Re: 2025 Waterline Improvements (PR#43-2025)
Falls City (PWS ID#00297)
Conditional Approval

The plans are approved with the following conditions needing to be met prior to Final Approval:

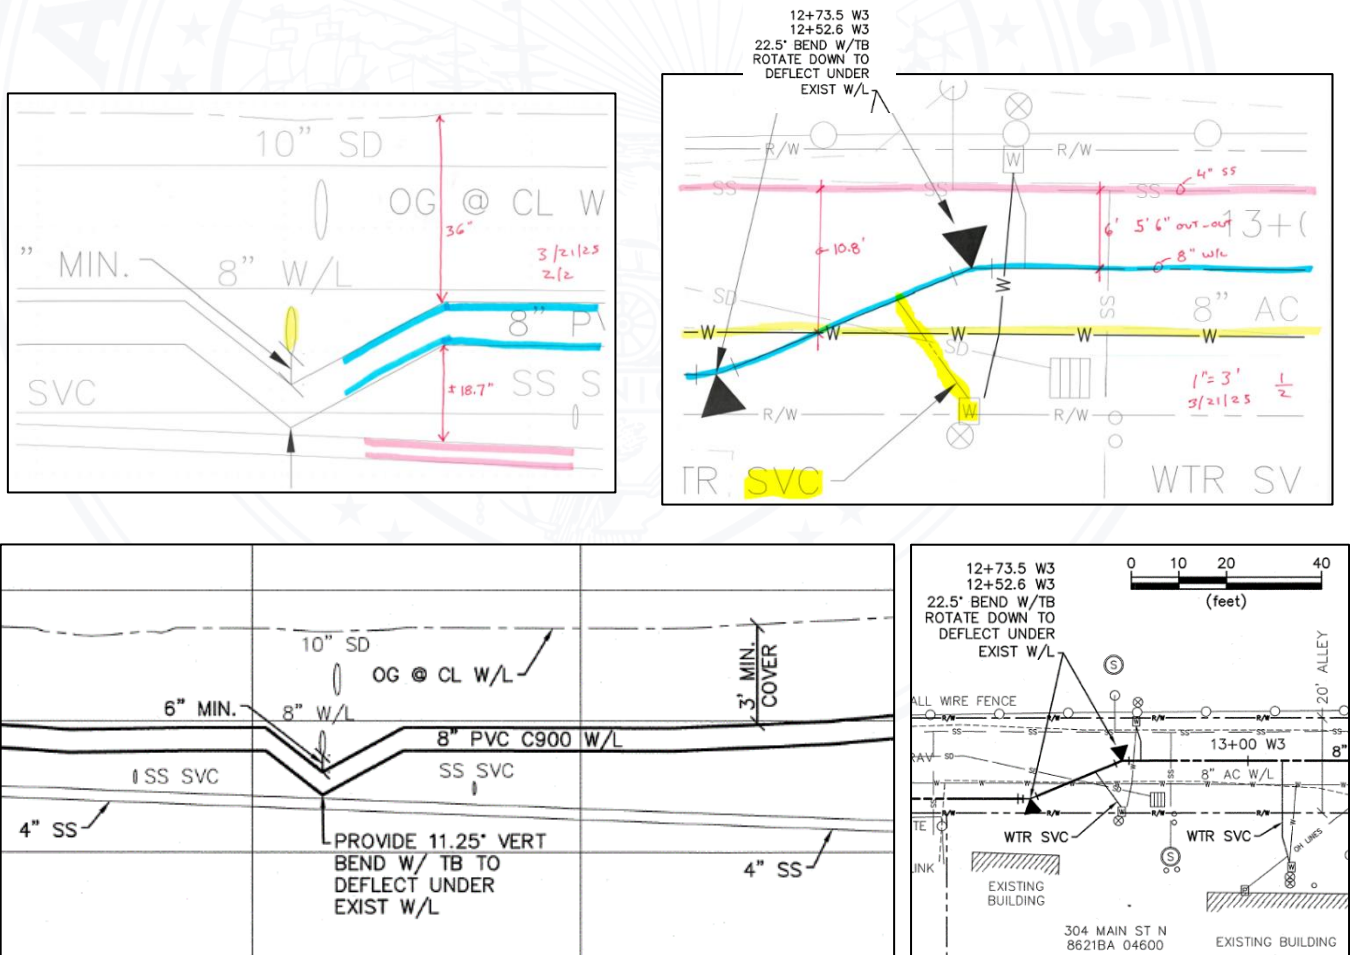
1. All items in contact with potable water must meet NSF Standard 61 or equivalent.
2. The design must allow for 20 psi to be maintained at all service meters.
3. As indicated in construction note #77 on drawing G003, water and sewer line crossings conform to OAR 333-061-0050(9). Waterlines running parallel to sewer lines must also meet OAR 333-061-0050(9) – see enclosure. There are several sewer line crossings in the Main Street Area and a section shown on drawing C103 of the new waterline having less than 10-ft separation from a parallel sanitary sewer line within a 20' wide alley between 2nd and 3rd. **In that same alley is a service line connection shown below that will need to be moved east of the east end of the bend where the new waterline is deflected under an existing AC waterline to ensure it is in Zone 1.**

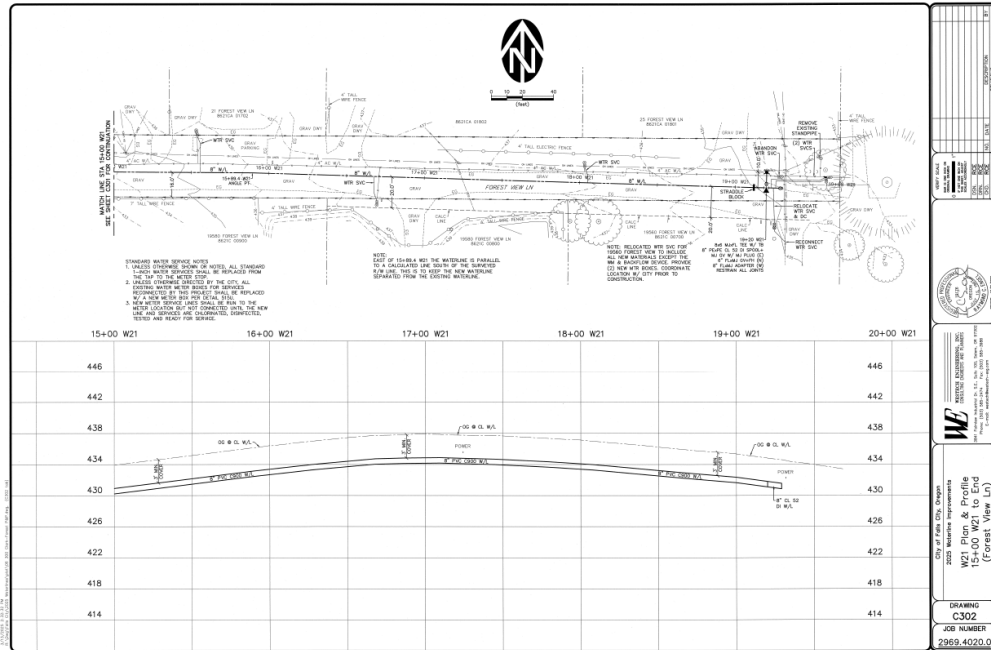
4. Air-relief valves must be installed at high points where air can accumulate such as at the crest on Forest View Lane shown below on drawing C302 (unless otherwise mitigated). The breather tube on air-relief valves must be extended above ground surface and provided with a screened, downward facing elbow.
